10019 HAMBRIGHT RD

FEE: Pd 300.00 **AUTHORIZATION FOR WASTEWATER SYSTEM CONSTRUCTION**
DATE: 9/27/99 gc **VOID SIXTY (60) MONTHS FROM DATE OF ISSUANCE**

CONDITIONS OF IMPROVEMENT PERMIT

PROPOSED PLOT PLAN

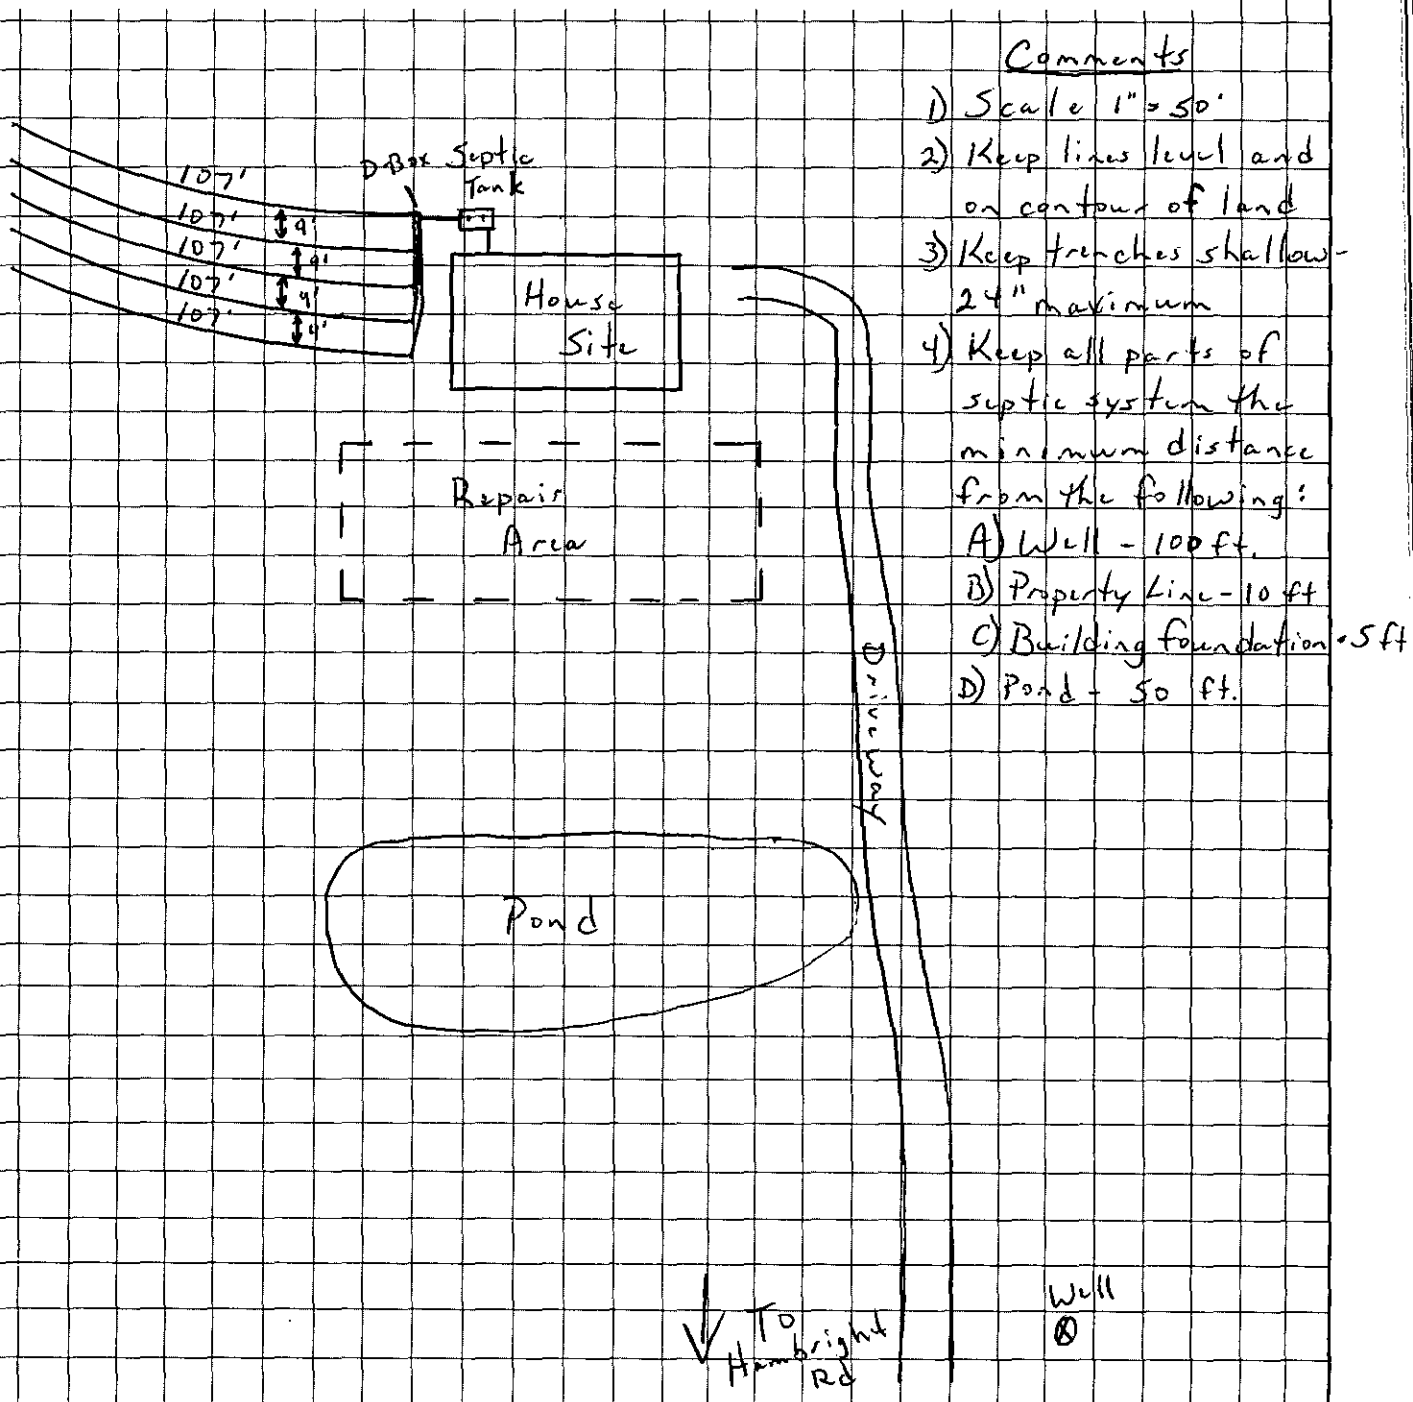
Comments

1) Scale 1" = 50'
2) Keep lines level and on contour of land
3) Keep trenches shallow - 24" maximum
4) Keep all parts of septic system the minimum distance from the following:
   A) Well - 100 ft.
   B) Property Line - 10 ft
   C) Building foundation - 5 ft
   D) Pond - 50 ft.
